July 2, 1991

SUBJECT: Calvert Cliffs Nuclear Power Plant
Unit Nos. 1 & 2; Docket Nos. 50-317 & 50-318
Single-Failure-Proof Upgrade and Technical Specification Change Request;
Spent Fuel Cask Handling Crane

EDR-1 APPENDIX B SUPPLEMENT
SUMMARY OF PLANT SPECIFIC CRANE DATA SUPPLIED BY EDERER
FOR CALVERT CLIFFS AUXILIARY BUILDING CRANE

EDR-1 APPENDIX C SUPPLEMENT
SUMMARY OF REGULATORY POSITIONS TO BE
ADDRESSED BY THE APPLICANT
FOR CALVERT CLIFFS NUCLEAR POWER PLANT
AUXILIARY BUILDING CRANE MODIFICATIONS

DRAWING A, SH. 1

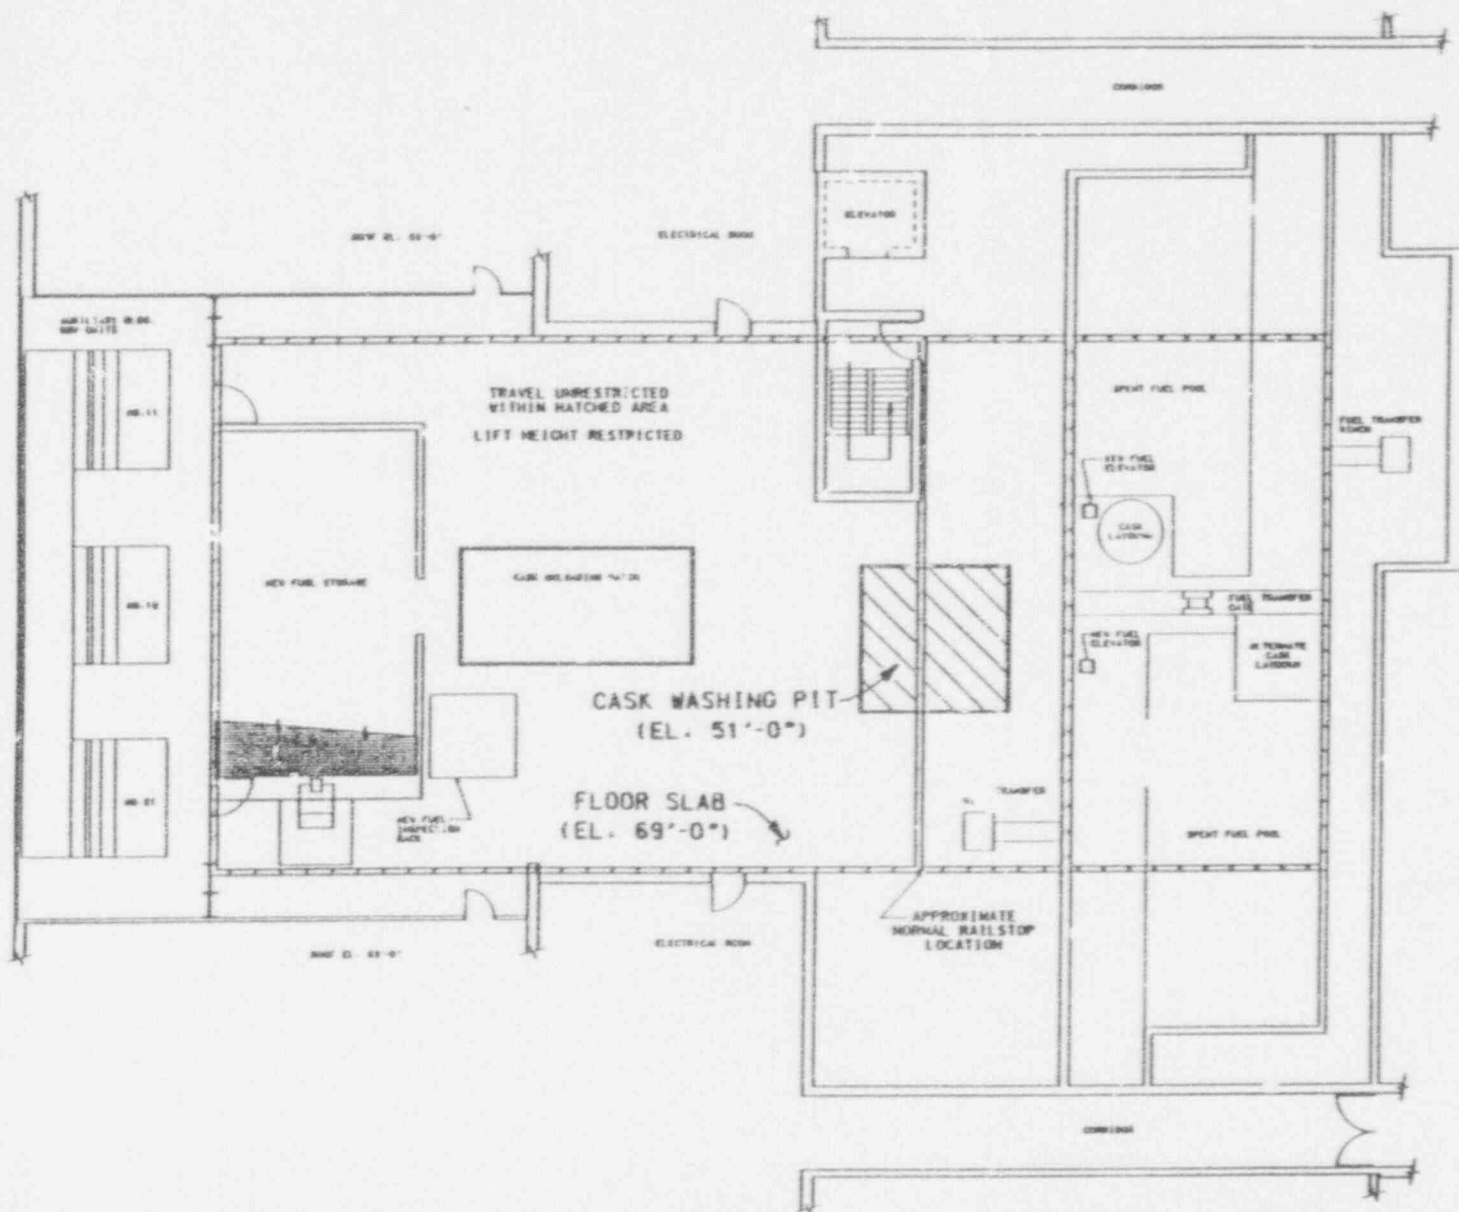
LAYDOWN AREA TO PLACE LOAD FOLLOWING
LOSS OF SPENT FUEL CASK HANDLING CRANE'S
SINGLE-FAILURE-PROOF CAPABILITY

DRAWING A, SH. 2

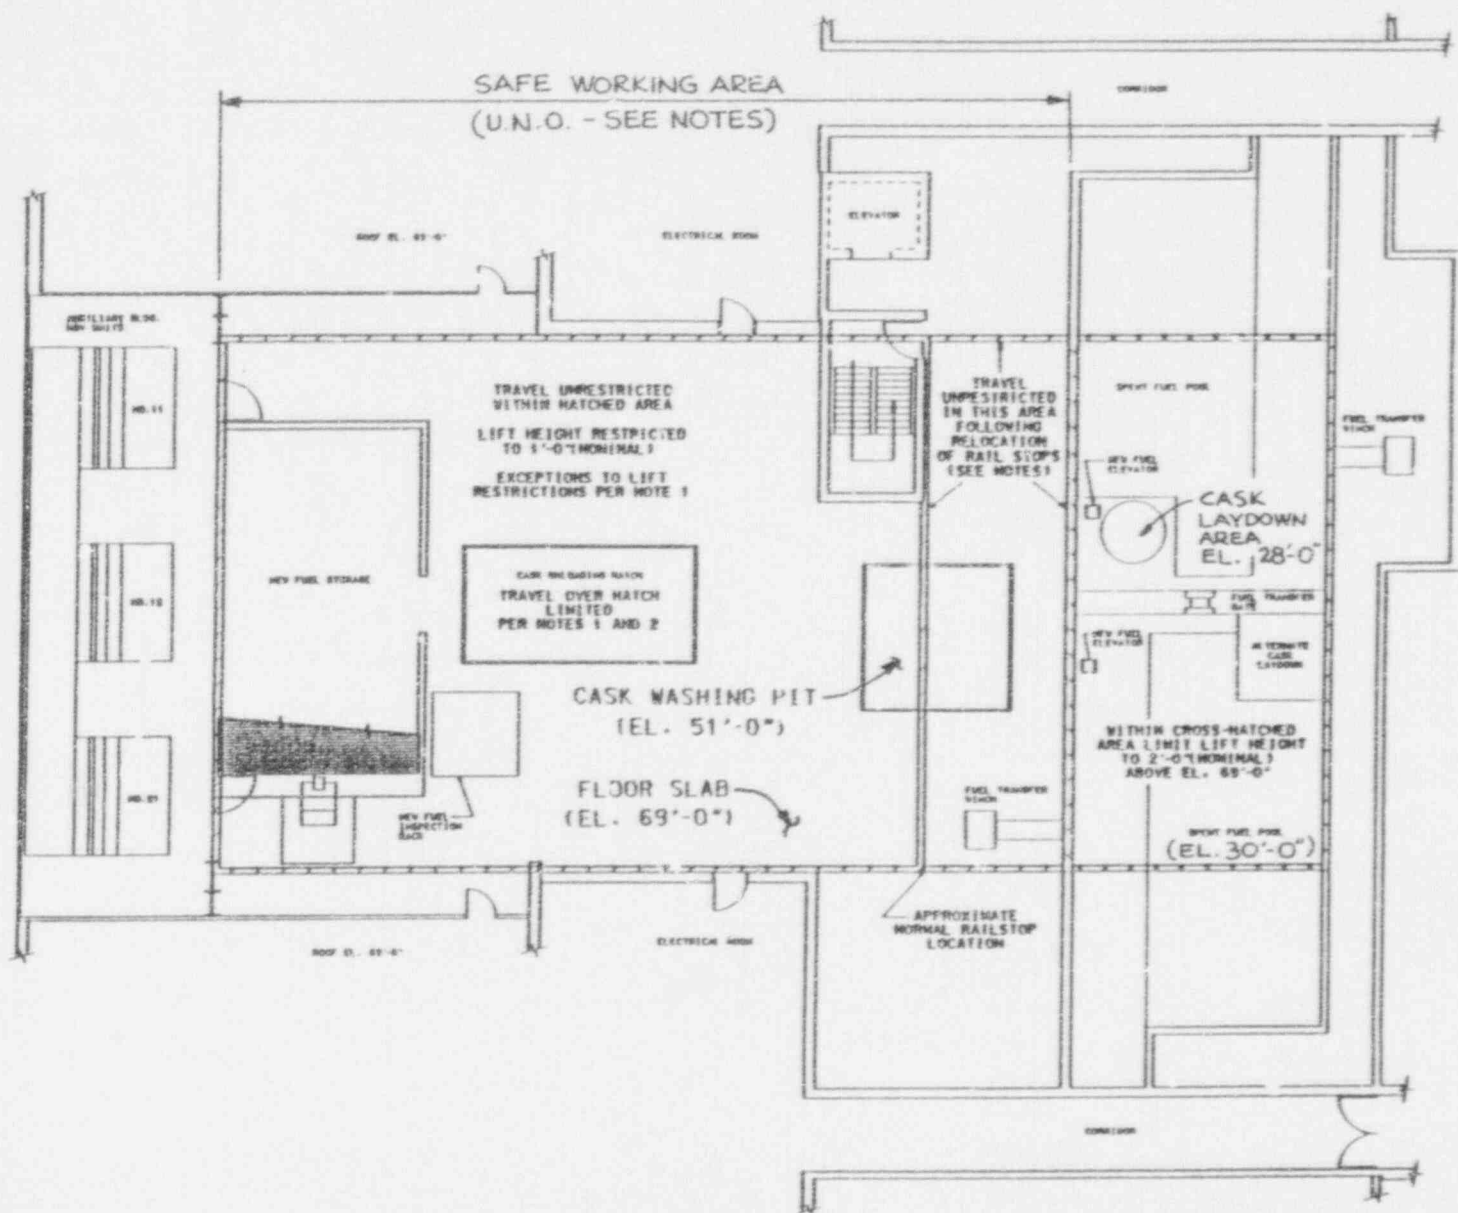
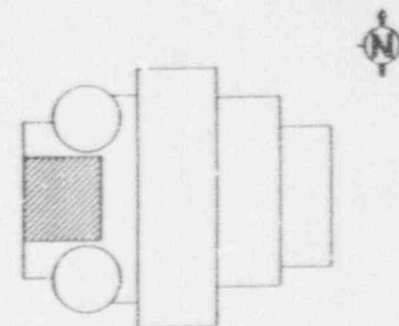
C.2.d	III.C. (C.2.d)	1. Size of replacement components that can be brought into the building for repair of the crane without having to break its integrity.	1. The replacement trolley components will be brought in through the Auxiliary Building, Cask Unloading Hatch, in accordance with Drawing "A", sheet 2. This means that any trolley component can be brought in to the Auxiliary Building if needed for crane repairs.

1. THE PURPOSE OF THIS DRAWING IS TO SHOW THE AREA TO PARK THE SPENT FUEL CASK HANDLING CRANE AFTER THE CRANE HAS LOST SINGLE-FAILURE-PROOF CAPABILITY AND REPAIRS NEED TO BE MADE. LIFTS REQUIRED TO MAKE REPAIRS MAY BE PERFORMED WITH NON SINGLE-FAILURE-PROOF CRANE SUBJECT TO RESTRICTIONS PROVIDED ON THE DRAWING AND IN THE FOLLOWING NOTES:

- a. FOR LOADS CARRIED OVER FLOOR AREA WEST OF SPENT FUEL POOL, LIFT HEIGHT IS RESTRICTED AS FOLLOWS:
 - 1. 14,000# - 18'-0" (NOMINAL)
 - 2. 50,000# - 3'-6" (NOMINAL)
 - 3. 50,000# - 1'-6" (NOMINAL)

ANY LIFT OVER 1'-6" (NOMINAL) REQUIRES APPROVAL OF APPROPRIATE AUTHORITY. LOADS SHOULD BE CARRIED AS LOW AS PRACTICAL.

- b. RAISING, LOWERING, OR TRAVELING LOADS OVER THE UNLOADING HATCH AREA IS TO BE AVOIDED. LOADS 6000# REQUIRE APPROVAL OF APPROPRIATE AUTHORITY.
